Work Order ID 129815

Item ID: D5149-1 Accept ***N900040100*** Setup Start ***NS1***
 Revision ID: Stop ***NS2***
 Item Name: Fwd Step Base
 Start Date: 2/23/15 Start Qty: 16.00 ***16*** Cust Item ID:
 Required Date: 2/23/15 Req'd Qty: 16.00 ***16*** Customer:
 Reference:

WORK ORDER NON-CONFORMANCE / UPDATE

Work Order: <u>129815</u>	DISPOSITION Rework ☐ Scrap ☐ Use-as-is ☒ Suspected Unapproved ☐	AGAINST DEPARTMENT/PROCESS			
Part No. <u>DS149-1</u>		Skid-tube ☐	Crosstube ☐	Water Jet ☐	Engineering ☐
NCR No. <u>15-4801</u>		Machining ☒	Small Fab ☐	Prod. Eng. Coord. ☐	Quality ☐
		Thermoforming ☐	Finishing ☐	Rec/Store/Packaging ☐	Other ☐
		Large Fab ☐	Composite ☐	Supplier ☐

D5149-1 FWD STEP BASE
 (MAKE FROM D5149-1TRN)

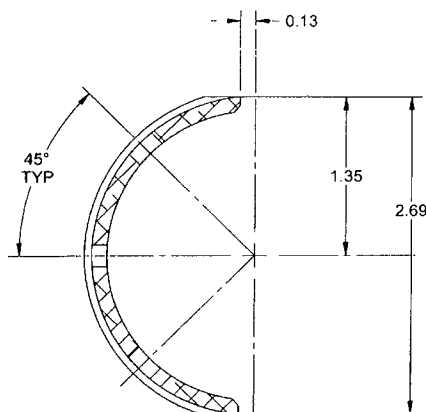
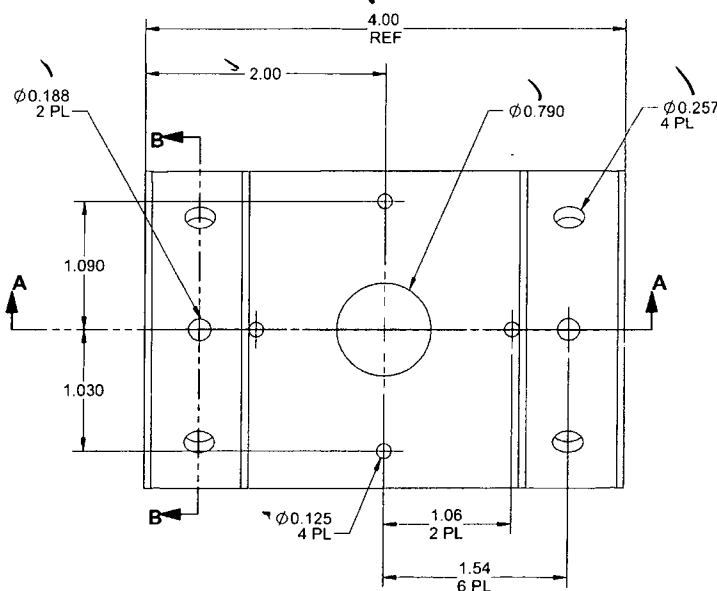
Root Cause	Date	Step	Qty	Description of work order update or non-conformance	Initial Chief Eng	Action Description	Sign & Date	Verification	QC Inspector
Design									
Doc/Data	15/3/30	100	16	Acceptable to do R0.063 instead of chamfer around perimeter	DAS 12 9-89 15/3/30	Rad. acceptable.	DAS 12 9-89 15/3/30	J.E. 15/03/31	DAS 9 9-89 1504.01
Equip/Tooling									
Handling/Pre									
Material									
Operator ☒				R.C. operator					
Offset/Setup									
Process									
Supplier									
Training									
Transport									
Unapproved

RO.063 *q* 15/1/30
 OR
 0.06 X 45° CMF
 ALL AROUND INSIDE EDGE
